Serial N°: 09/833,978

For: Electrical Interrupt Switch

Request for Correction to the Drawings Under 37 CFR § 1.123

In Figure 2:

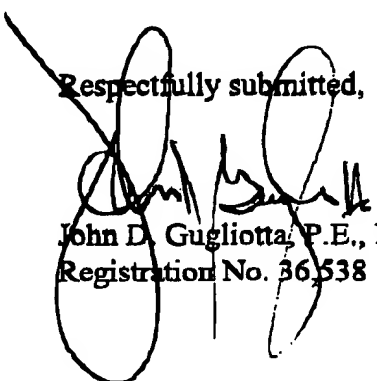
As requested and shown, please delete reference numeral "42" as indicated, while adding cross-hatching to reference numeral "18".
